Service Bulletin

SUBJECT: Service Update for Inventory and Customer Vehicles
Software Enhancement Update
Expires with Base Warranty

MODELS: 2013 Chevrolet Sonic, Spark, Trax
Equipped with MyLink Radio (UF7)

Subject: 13128C – Service Update
Software Enhancement Update
Revised Service Procedure

3286662

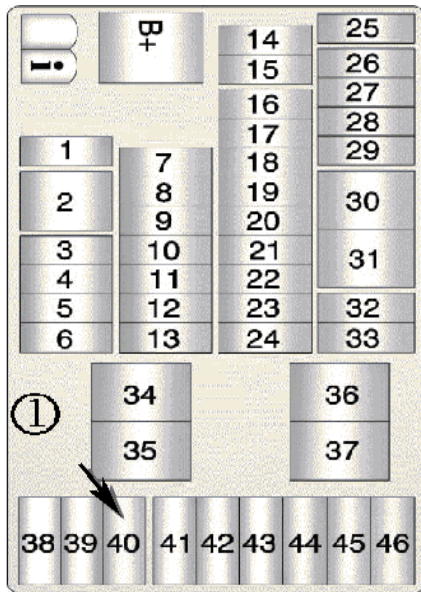
8. If you see the message as shown above "The following update file is Invalid SMD file," continue to the next step. Otherwise, skip to Step 14.

Fuse Block Locations (Driver Side IP)

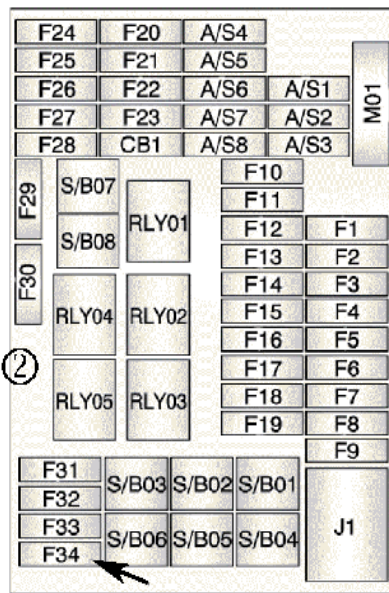
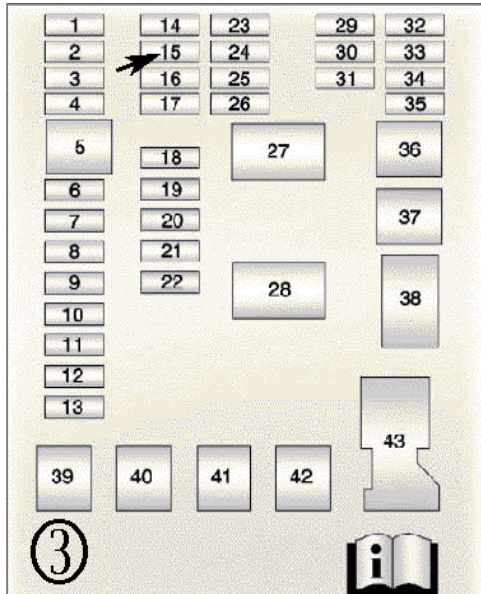
9. With the ignition off, pull the OnStar® 10 amp fuse from the fuse block of vehicle.
 - (1) Spark
 - (2) Trax
 - (3) Sonic
10. Turn the ignition back on.

17. With the ignition turned back off, install the OnStar® fuse back into the fuse block.

Note: CONFIRM that the OnStar® fuse has been inserted back into the fuse block after performing the programming event. Ensure ONSTAR is FUNCTIONAL prior to releasing vehicles back to the customer.
